# CITY OF ALBUQUERQUE

RE: **Navarette Residence**  
**10516 Olympic NW**  
**Grading Plan**  
**Engineer's Stamp Date 6/14/17 (File: A12D028)**

Based on the information provided in your submittal received 6/21/17, the Grading Plan cannot be approved for Building Permit until the following are addressed:

NAVARETTE RESIDENCE 10516 OLYMPIC	DRAWN BY WCWJ
	GRADING AND DRAINAGE PLAN	DATE 6-13-17
6/14/17		21741-LAYOUT-5-29-17
DAVID SOULE P.E. #14522		SHEET # —
	1606 CENTRAL AVENUE SE SUITE 201 ALBUQUERQUE, NM 87106 (505) 872-0999	JOB # 21741

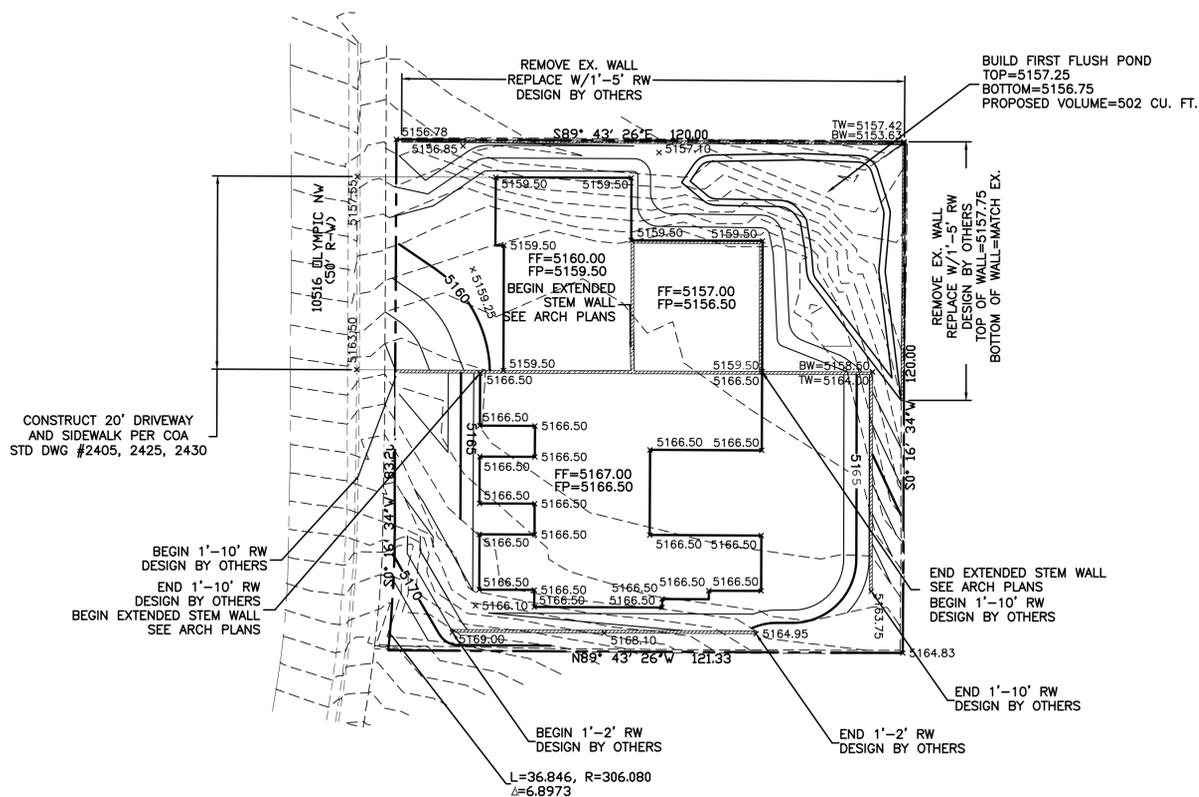
1. Section Views. Provide section cuts of several areas across this site:
  - a. The southwest corner, between the SW corner of the house, to the adjoining lot to the south.
  - b. In the back yard, through the two retaining to the property to the east.
  - c. The northwest corner, between the NW corner of the garage to the adjoining property to the north.
  - d. In the northeast corner, through the lowest floor at 5157.00 and the ponding area.

Ensure these section views show that the flowline is not set against any retaining walls or walls of the house and ensure below-grade finished floors have waterproofed retaining walls.

2. Contours. Extend the topographic data around all of the lot lines, not just on the west side of the lot. Also label contours for existing and increase label density of the proposed contours.
